VALUE ENGINEERING PROPOSAL

NEW BEDFORD HARBOR SUPERFUND SITE
 UPPER AND LOWER HARBOR (OU#1)
 NEW BEDFORD, MASSACHUSETTS

APPROXIMATE LOCATIONS OF AREAS
 TO BE DREDGED AND CONFINED
 DISPOSAL FACILITIES

**CDF D
ALTERNATIVE A
TYPICAL BULKHEAD SECTION**

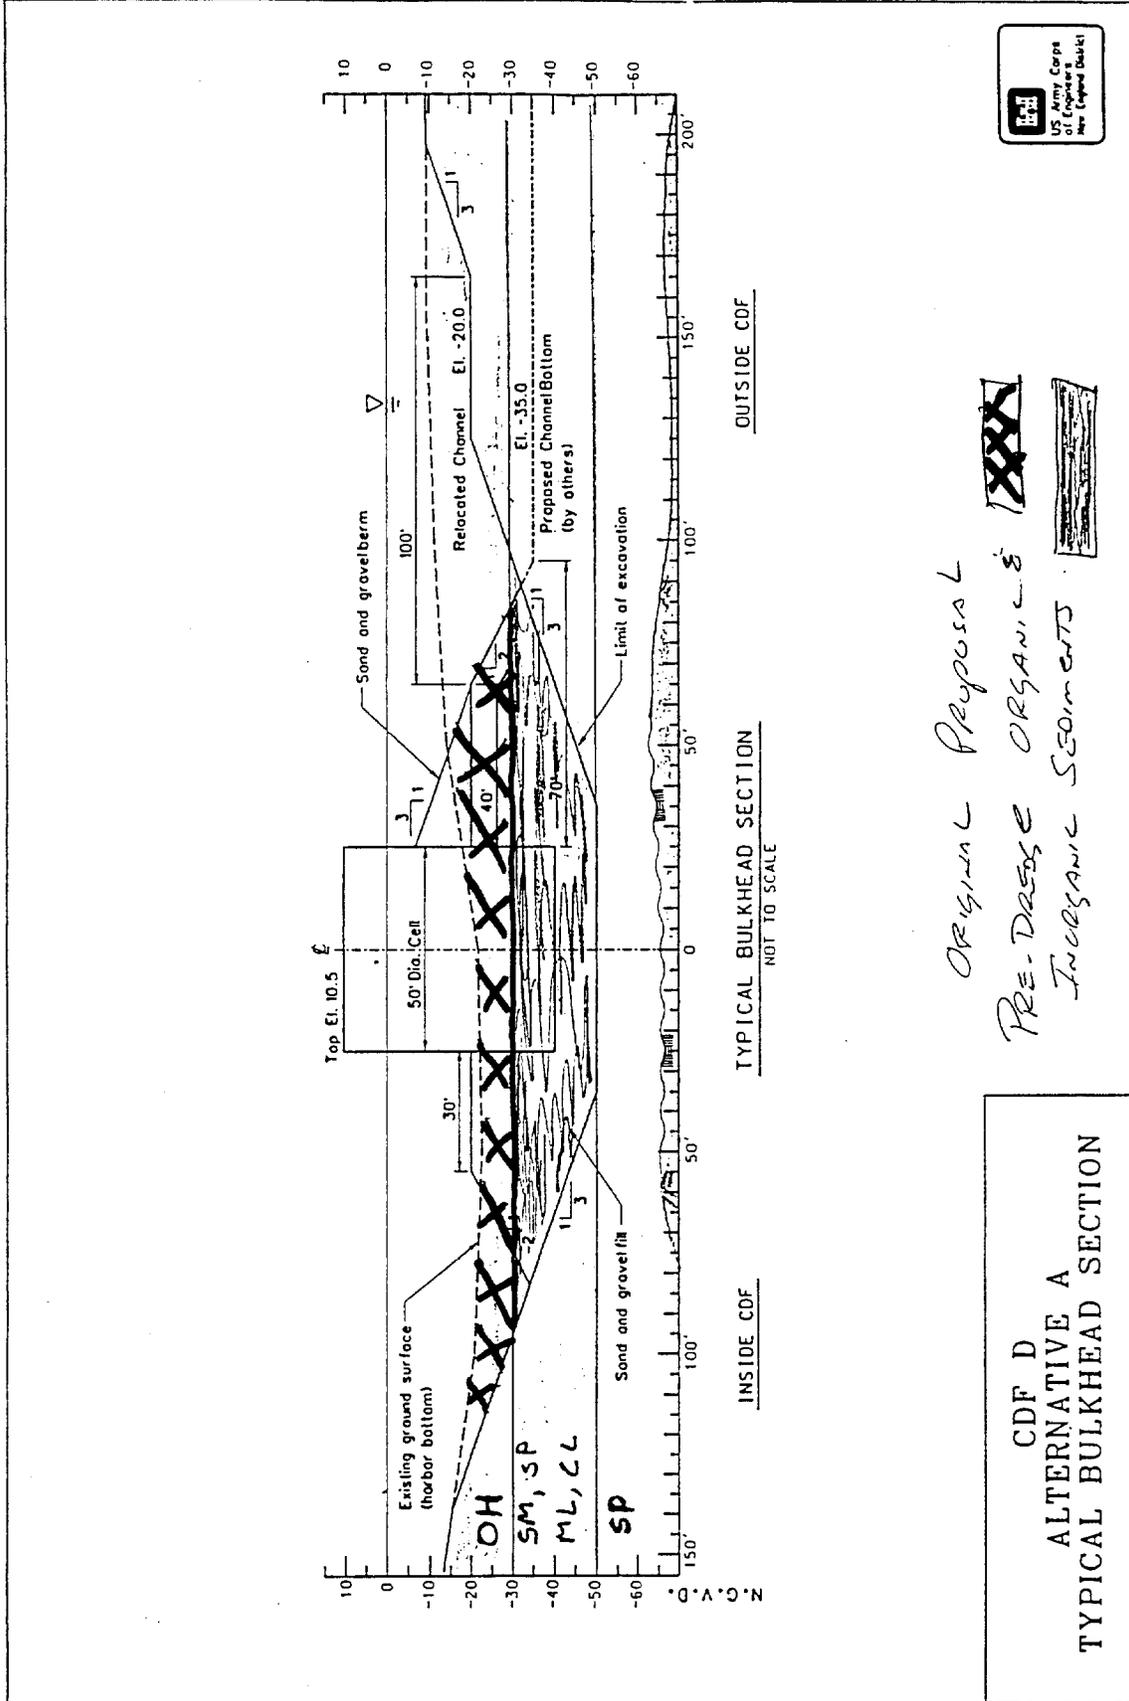
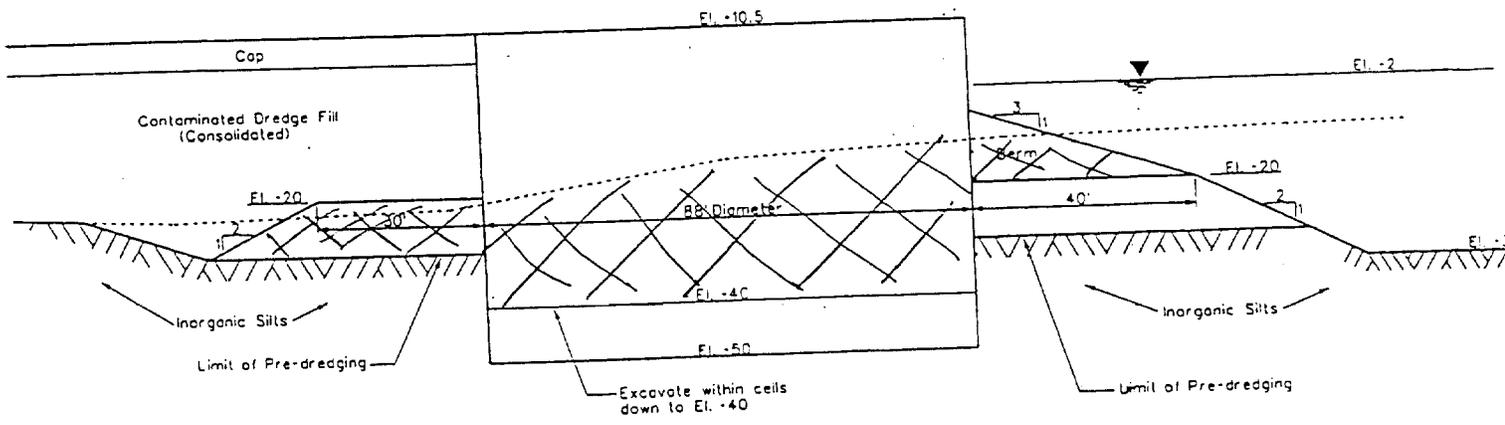
PROPOSAL NO:	C-14	PAGE NO:	1 OF 5
DESCRIPTION:	Eliminate Pre-Dredge of Inorganic Material along CDF "D" Bulkhead Footprint

A3 alternative – cellular sheet-pile wall along original alignment. In this design the underlying organic and inorganic sediments underneath the CDF "D" footprint would be dredged out and replaced with a more suitable foundation material prior to driving the sheeting (See Drawing No. 1).

A3 alternative – cellular sheet-pile wall along original alignment. In this design only the organic sediments underneath the CDF footprint would be dredged out and replaced with sand. Need to dredge 10 feet of inorganics in the cell and increase cell size to 88 feet in diameter. (See Drawing No. 2).

Increases the size of the sheet pile cells to accommodate the wall stability. This decreases storage volume and/or increases encroachment toward channel.

Not economically justified, costs more in cell foundation stabilization.

DRAWING NO. 2

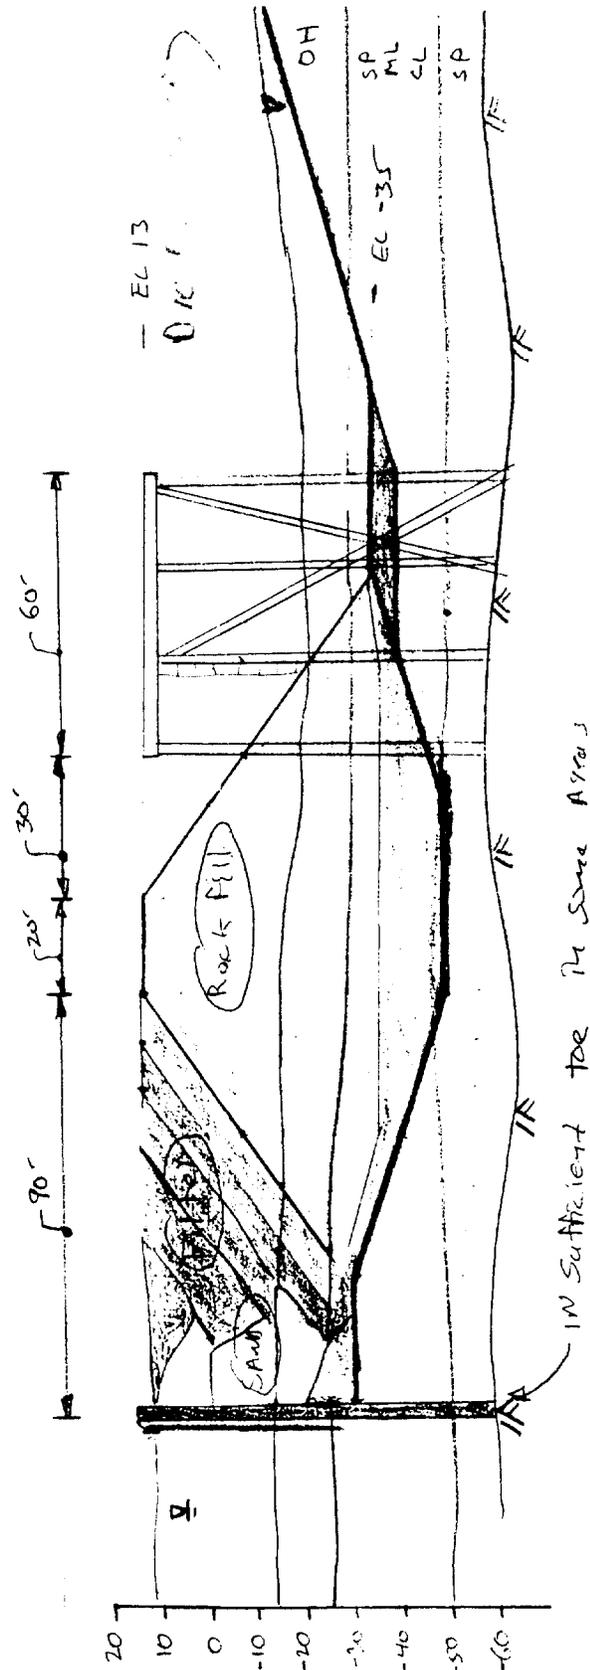
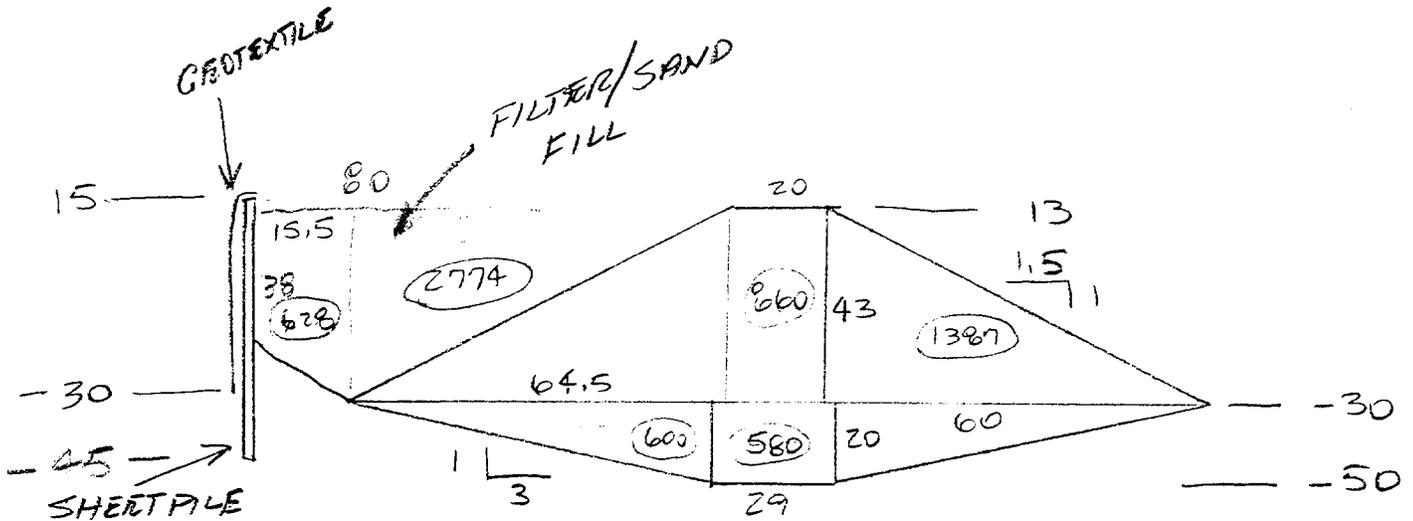
DESCRIPTION: Half Dike

The original design provides a cellular bulkhead sheetpile wall with berms and cutoff wall within sheetpile cells. (See Drawing No. 1, Appendix E and Proposal C-02).

Half embankment (See Drawing No. 2):

- Drive sheetpile wall to refusal
- Dredge to remove organic soils and inorganic silt
- Construct rock fill embankment – drive wharf piles
- Place gravel filter and sand filter with clamshell
- Install geo-membrane liner on sheet-pile wall
- Continue to back fill as dredge fill is placed
- Build wharf and retaining wall
- Place Class I almost at toe
- Possible use of deadman for temporary support

1. May be insufficient toe for sheets
2. Back-filling and dredge placement need to occur at same time
3. Deformations of sheetpile wall may be excessive and may damage liner
4. Liner needs to be placed from a barge
5. May be difficult to de-water; may need liner on both sides of sheeting

Allows for “leaky” cutoff wall, reduced pre-dredging, and slightly smaller embankment.

DRAWING NO. 1

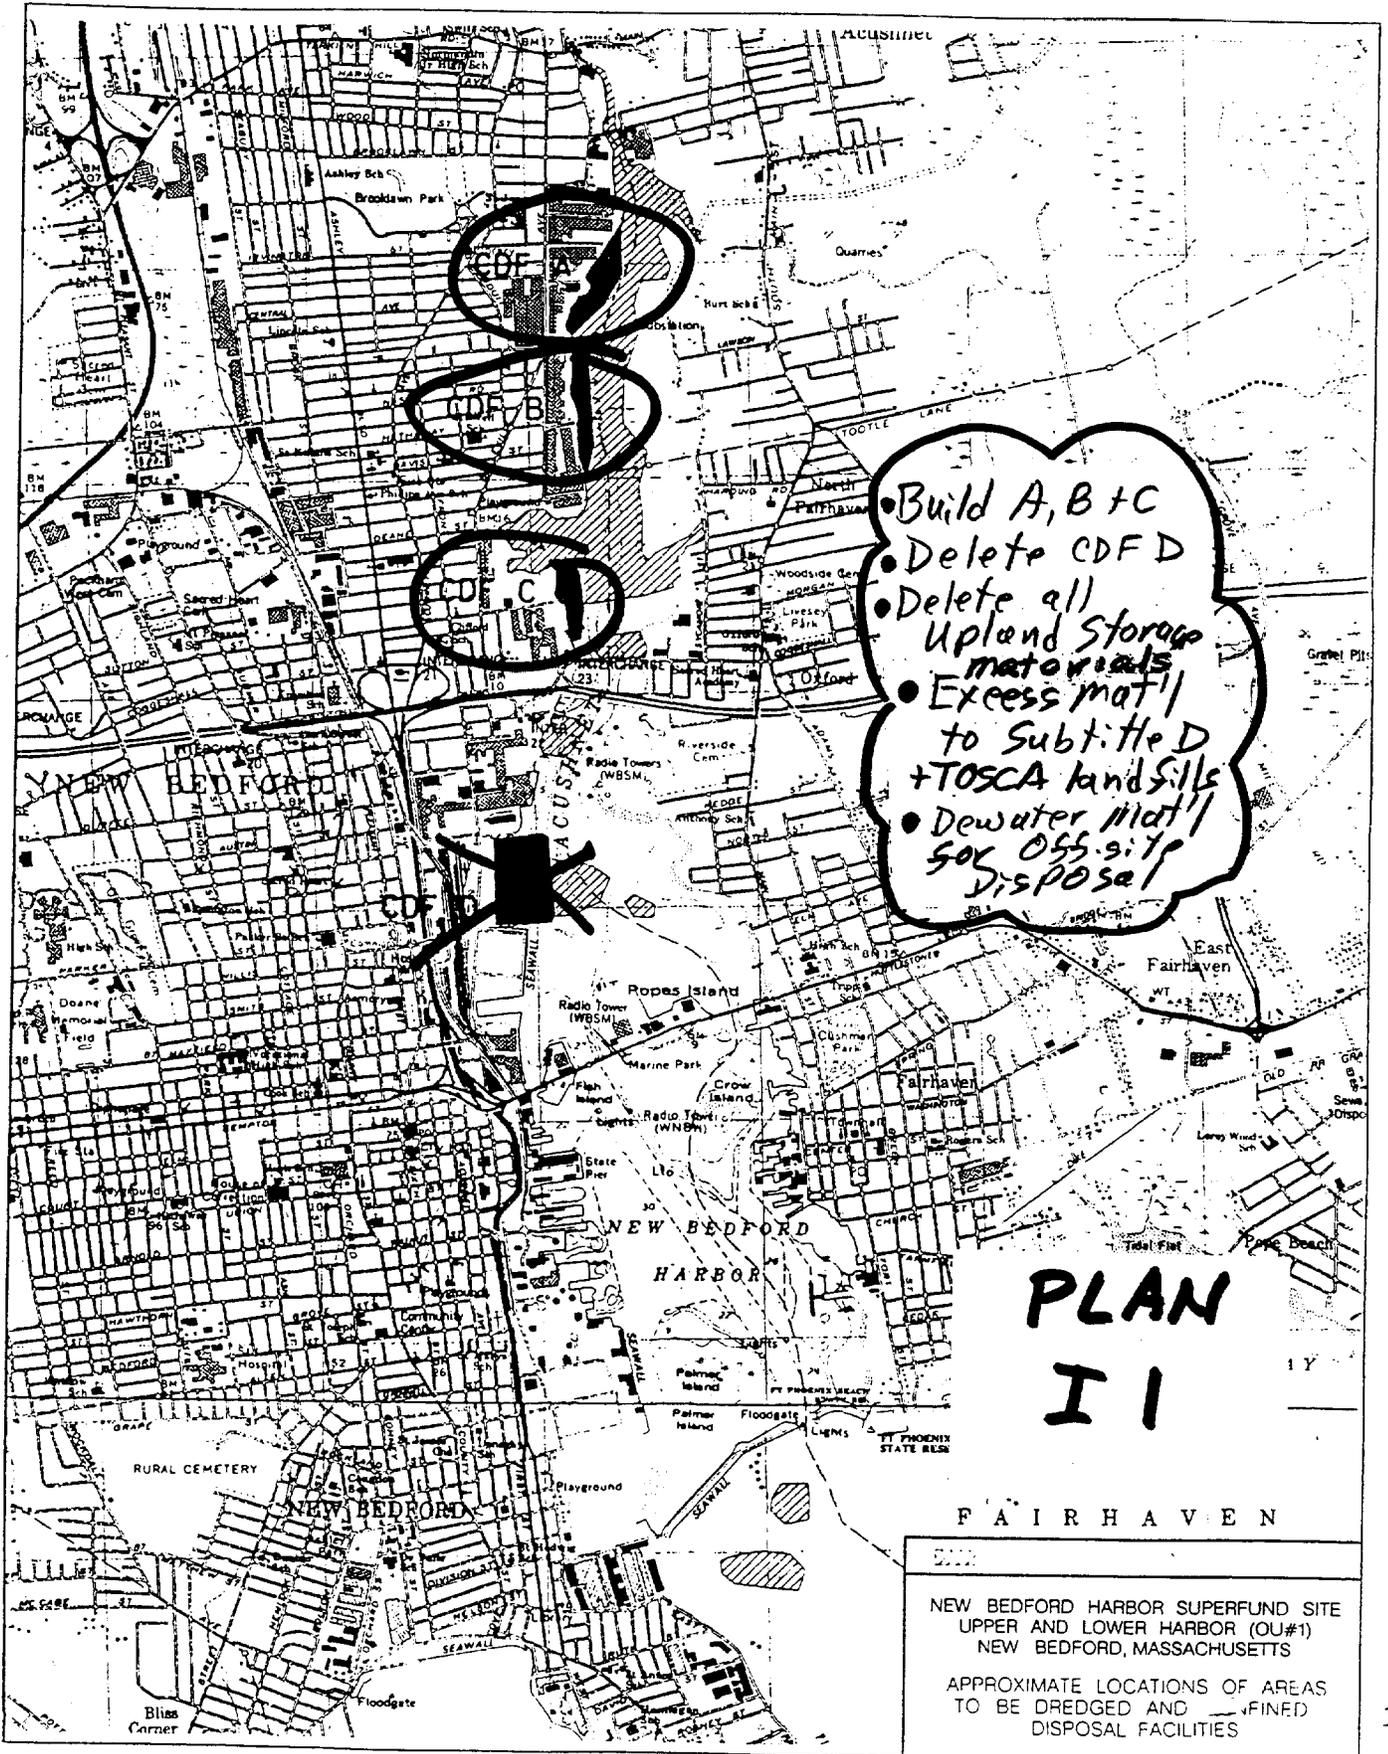
Plan D2 – New Alignment, no new channel.
Dewater harbor materials
Process/reuse foundation materials
Build 3 Upland Storage Sites
Delete CDFs "A", "B", "C"
CDF "D" el. 10.5

Plan I1 Construct CDFs "A", "B", and "C"; delete CDF "D"; delete all upland storage sites; excess material to subtitle D and TOSCA landfill; dewater material for off site disposal.

Plan I2 Construct CDFs "A", "B", and "C"; delete CDF "D"; delete all upland storage sites; excess material to subtitle D and TOSCA landfills; dewater all harbor and foundation material.

1. I1 and I2 - Uncertainties with dewatering costs.
2. No benefits to city due to lack of CDF "D" opportunities.
3. Low public desire.

Not Economically justified. Both Plans I1 and I2 represent cost increases which exceed the Plan D2 baseline cost estimate by **\$61,039,247** and **\$35,586,140** respectively.

DRAWING NO. 2

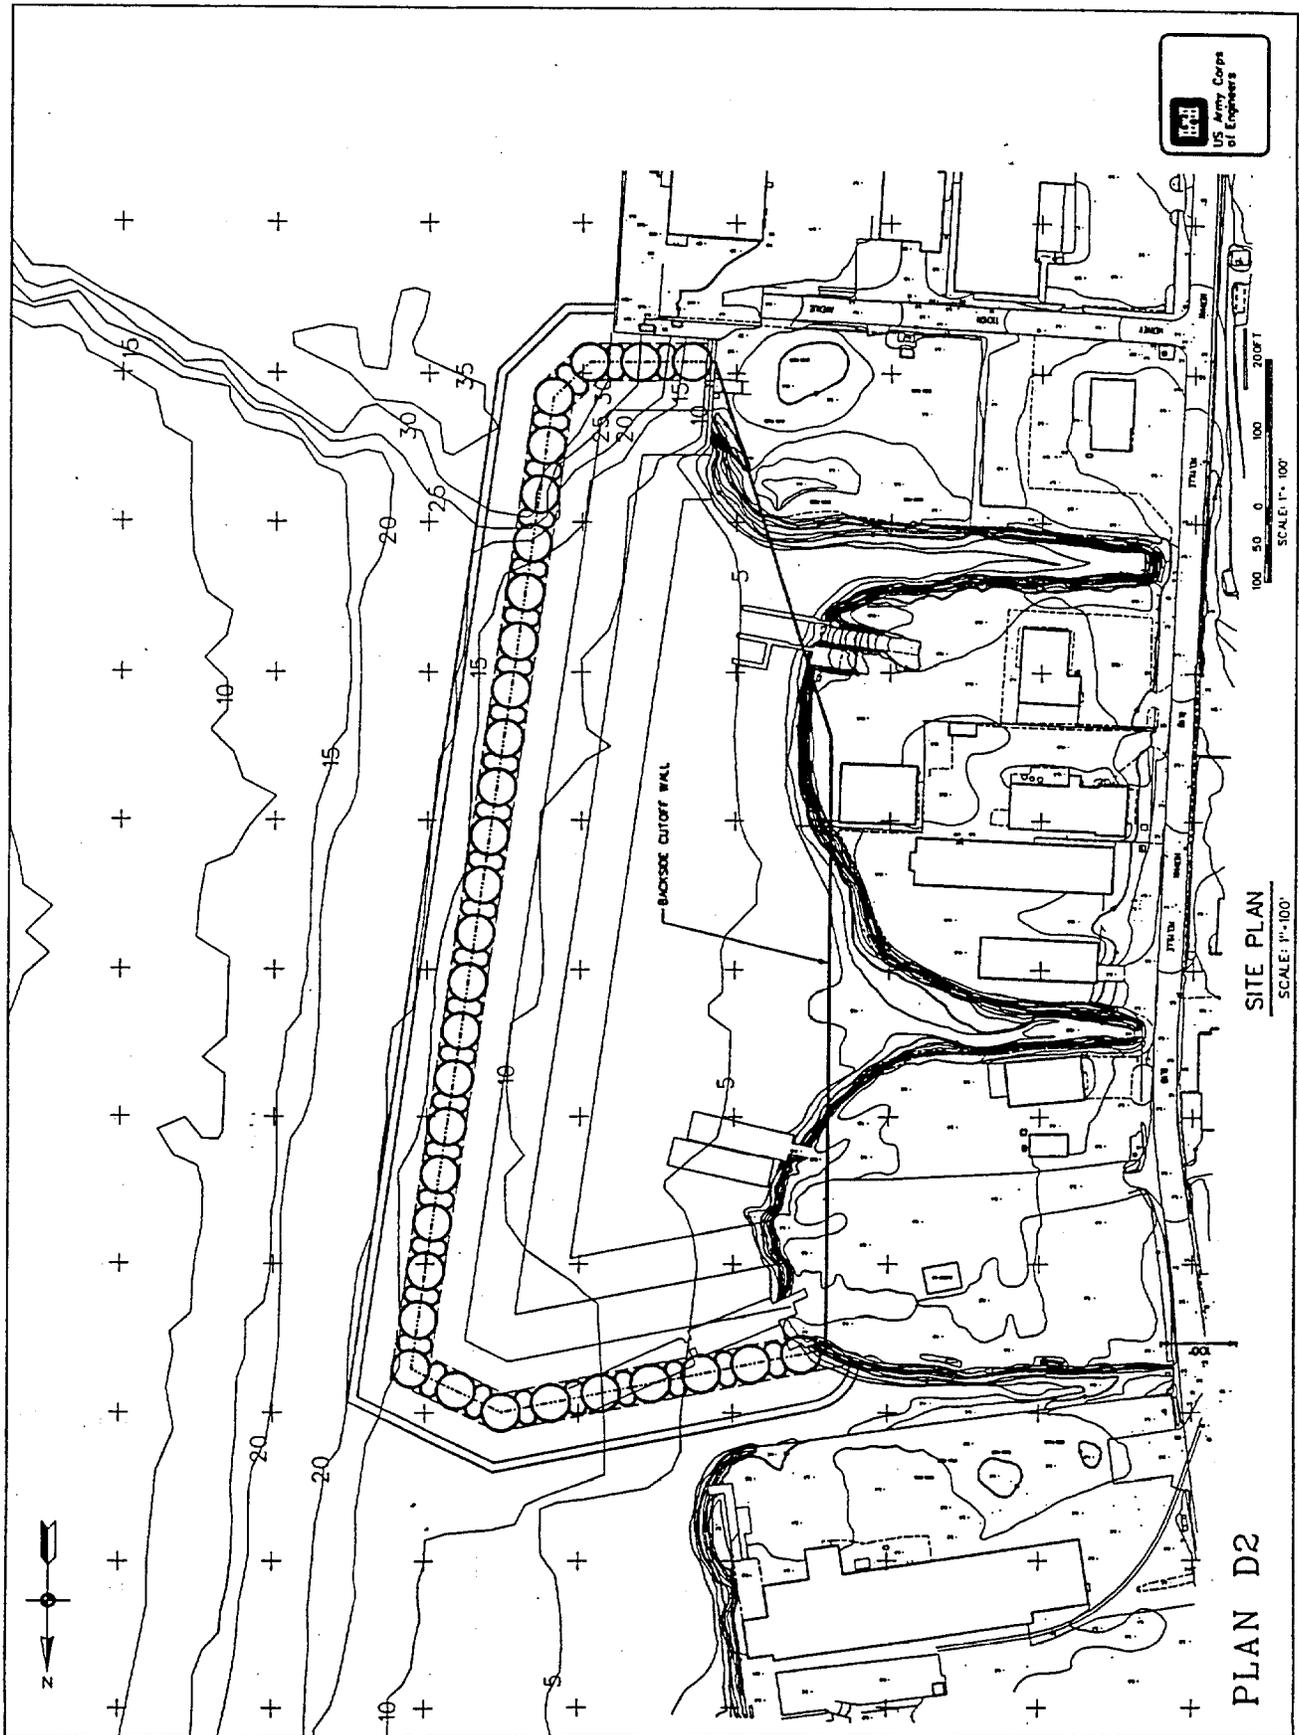
The current design specifies cell and arc construction, 50.14 feet in diameter. The design used as basis for this proposal is Plan A-1. (See Drawing No 1).

The goal for this proposal is to reduce the size of the cells and to enhance the resistance of the primary mode of failure, vertical shear. The idea is to shop weld two sheet piles (the top 10.5 feet only). In addition to welding the top 10.5 feet, tack weld to the bottom of the paired piles. When the sheets are placed in the field, then field weld the adjoining sheets. In the end there will be all welded sheets, from top of sheet to 10.5 feet below the top of sheet.

1. Welding the top of steel sheet piles is a relatively new concept. Some additional analysis is warranted to validate the concept.
2. There may be another form of failure other than vertical shear, additional analysis is necessary.
3. May be difficult working with the templates, water and welding.

Additional capacity is needed for now and the future. There is a need to reclaim and protect the area to keep it from completely eroding away causing additional dredging and reduction of storage area.

DRAWING NO. 2

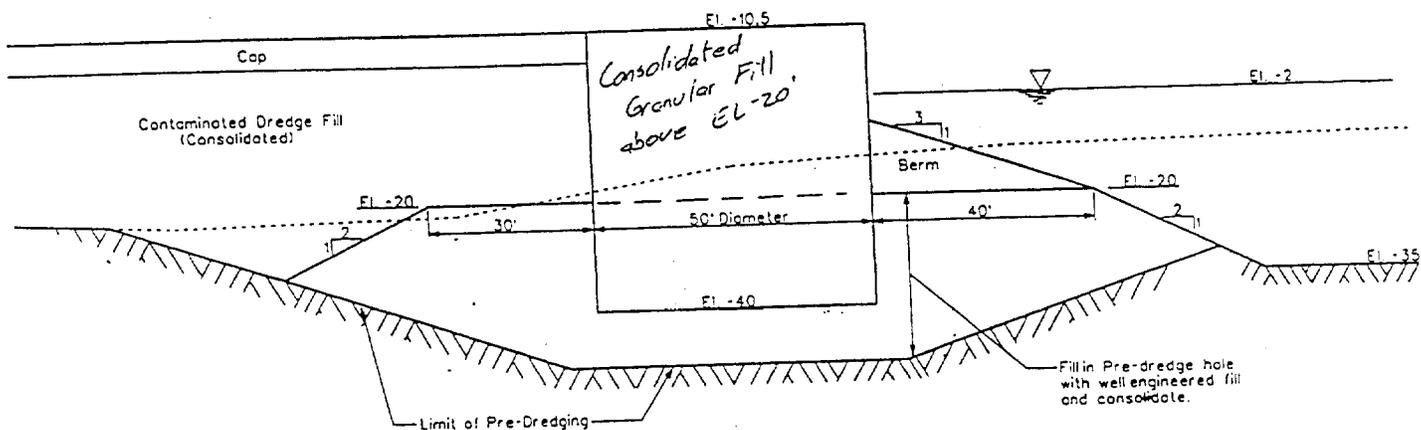
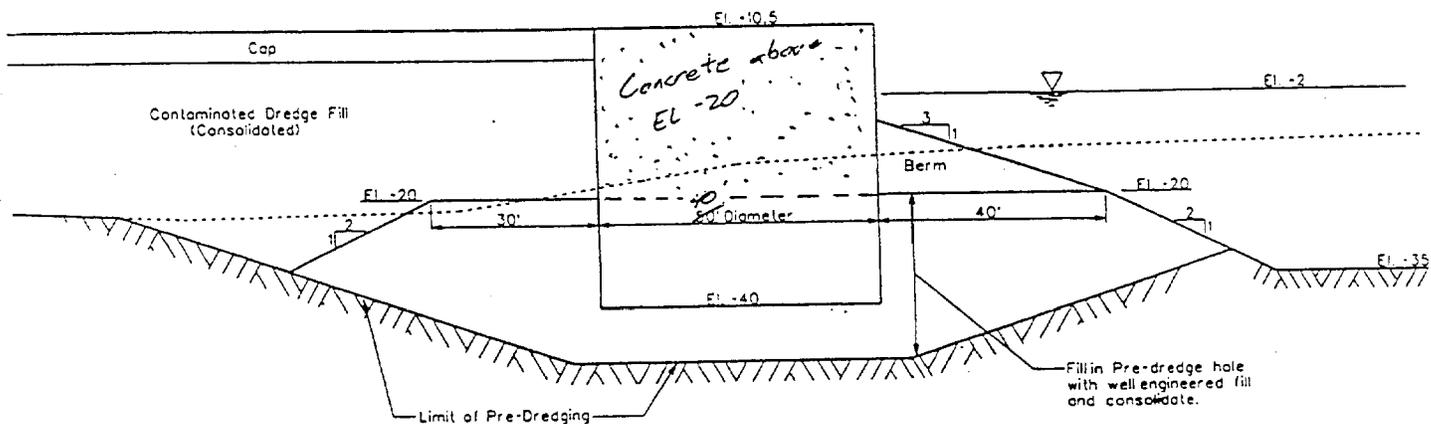
Cells are filled with engineered and consolidated granular fill (See Drawing No. 1 and Appendix E).

Fill cells with concrete, soil/cement mixture (batched prior to placement), or jet-grout cell fill materials in place (See Drawing No. 2).

1. Can't drive poles through it
2. Potential bearing problems
3. Cost of concrete or batching soil-cement
4. Foundation improvements will still be required

Smaller cell size could decrease costs and increase CDF storage capacity.
